PLANNING BOARD MEETING AGENDA

TO: Christian Smith, Beals Associates
FROM: Mark Connors, Planning & Community Development Director
RE: **Windsong Place Subdivision Staff Comments**

The applicant, Chinburg Properties, Inc. of Newmarket, NH, is proposing to construct a six-lot subdivision off Bunker Hill Ave. On the Town's behalf, CMA Engineers has reviewed the application for conformance with the Town of Stratham, NH, Site Plan Review Regulations. CMA Engineers has received the following information for review, all prepared by Beals Associates, PLLC of Stratham, NH:

**SUBDIVISION PLAN
FOR
KENNETH F. LANZILLO
IRREVOCABLE TRUST
OF
TAX MAP 6 LOT 167
189 BUNKER HILL AVENUE
STRATHAM, NEW HAMPSHIRE
COUNTY OF ROCKINGHAM**
SCALE: 1"=60' (22x34) 1"=120' (11x17)

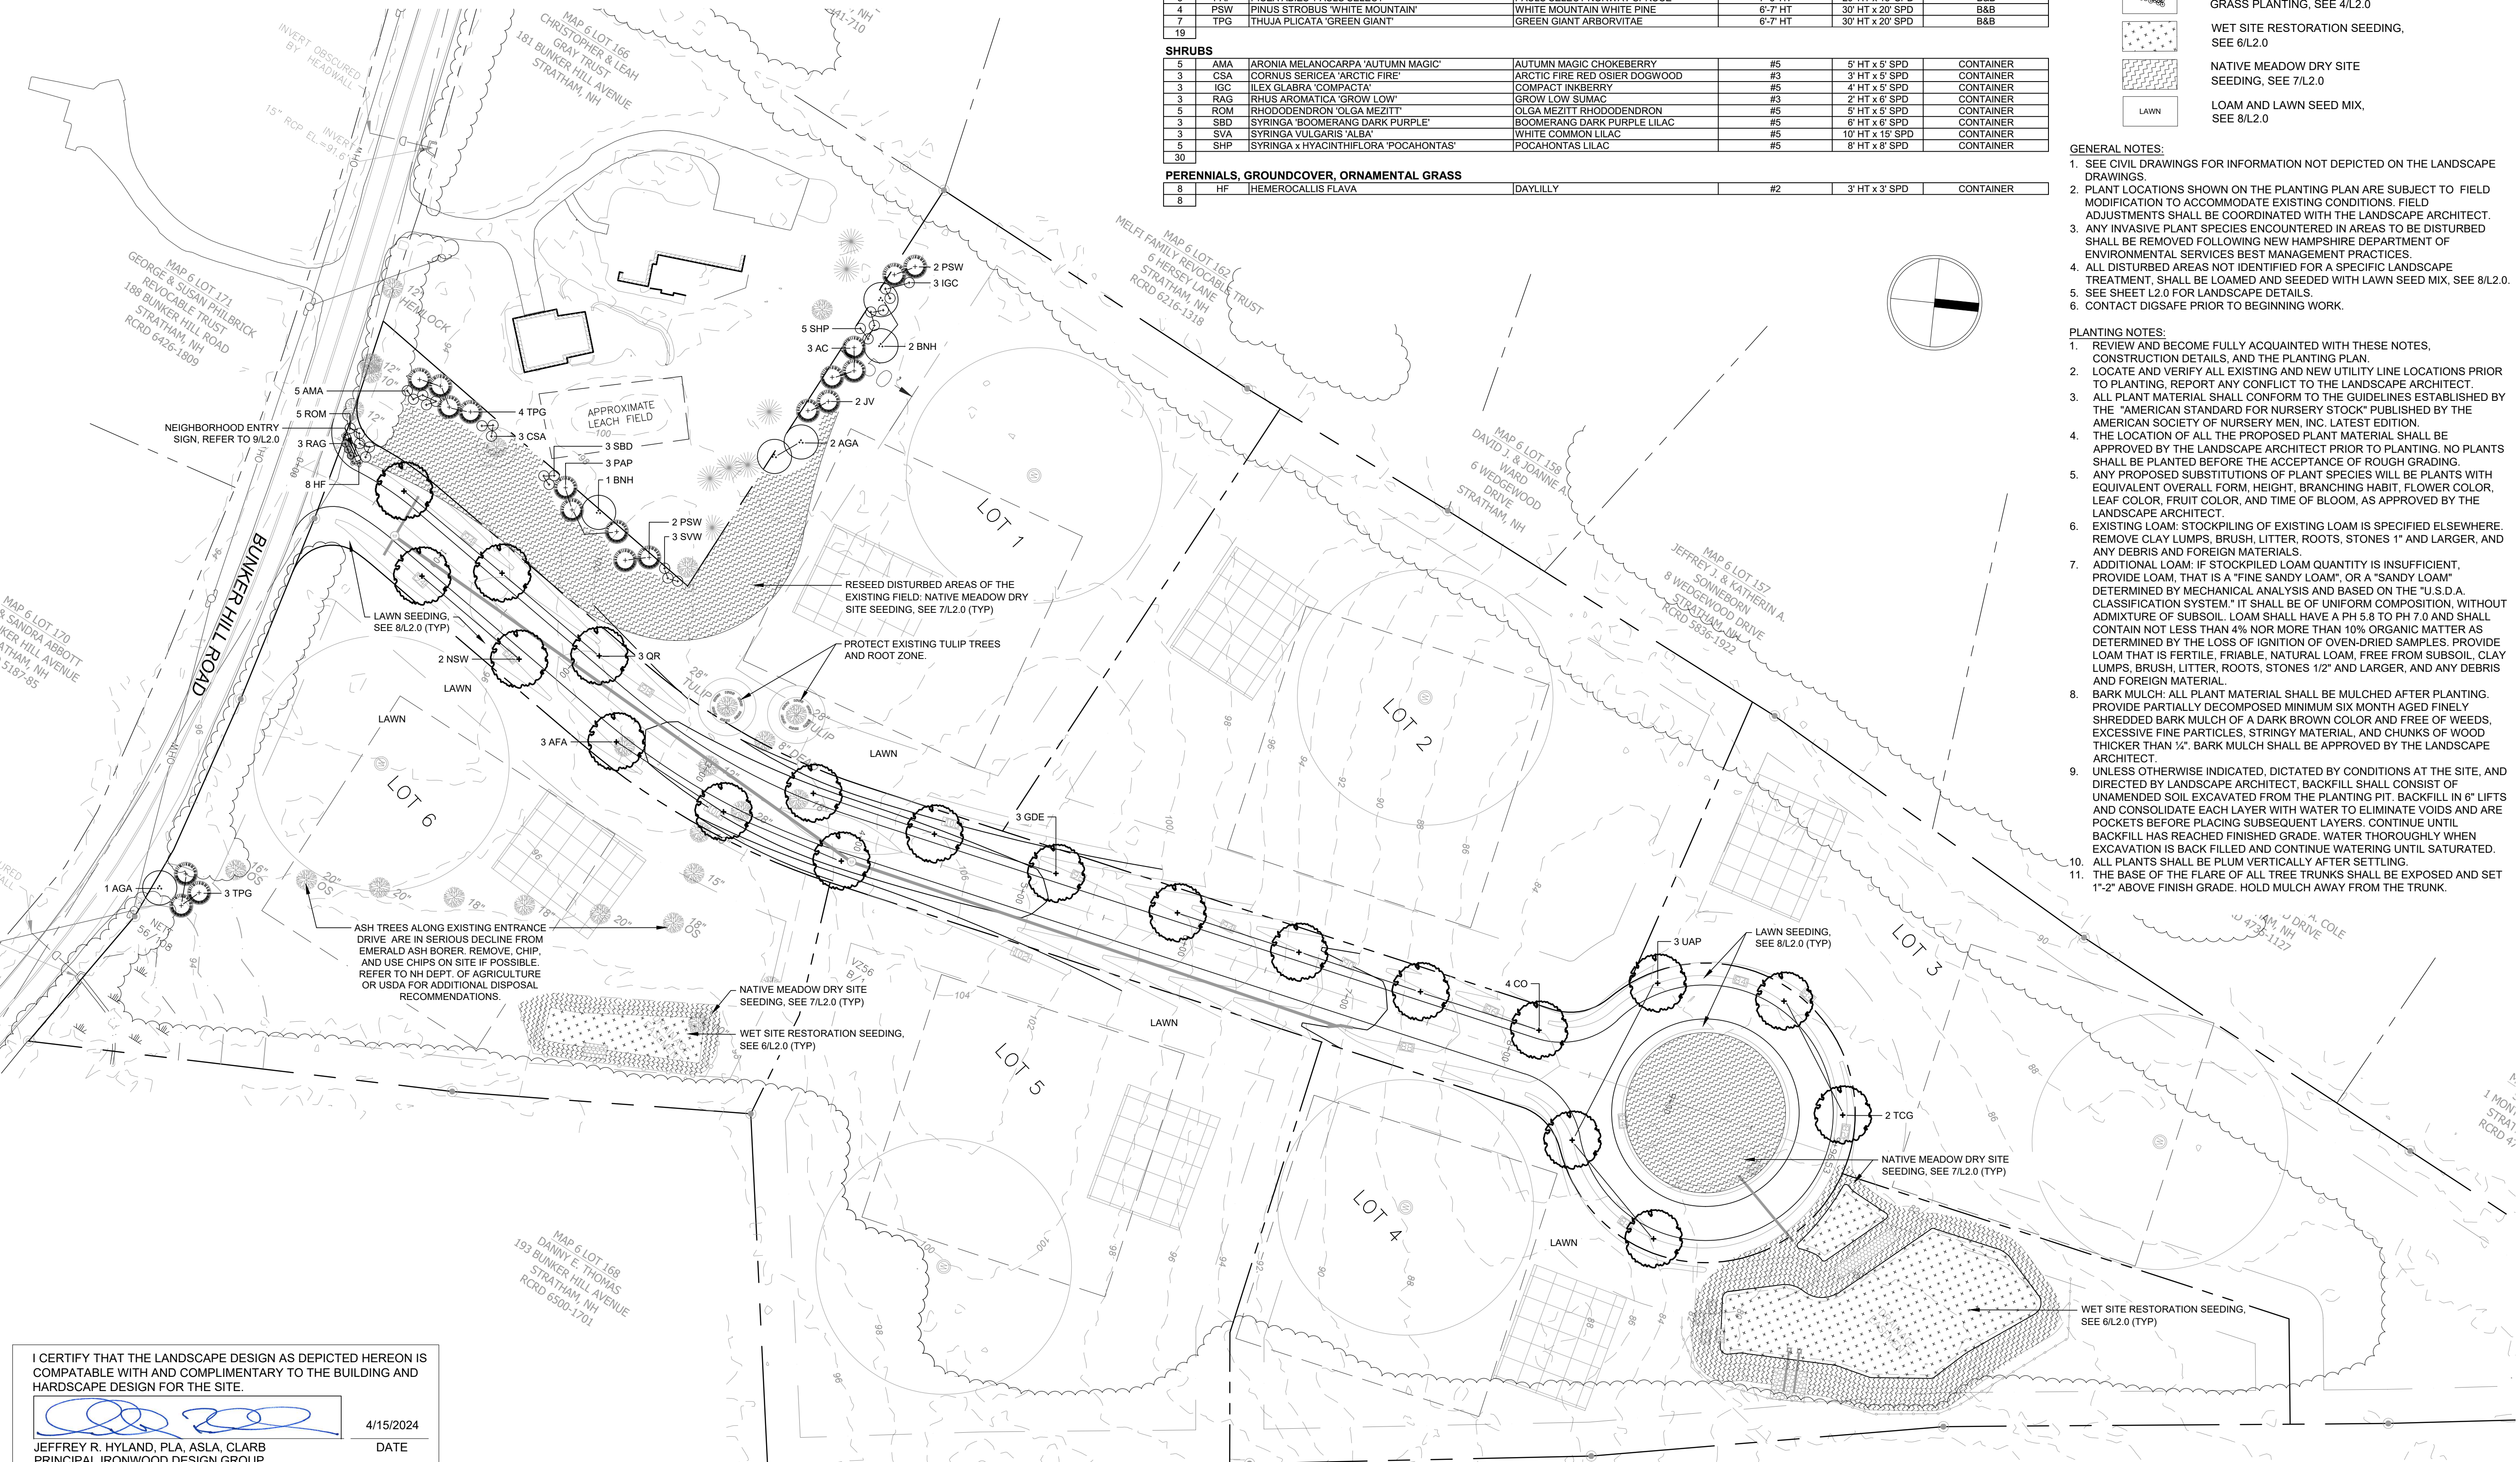
- 6) Staff would strongly recommend a landscaping plan to help provide some screening of the detention pond located at the end of the cul-de-sac.
Response: See Landscape Plan (Sheet 11) that has been added to the plan set.
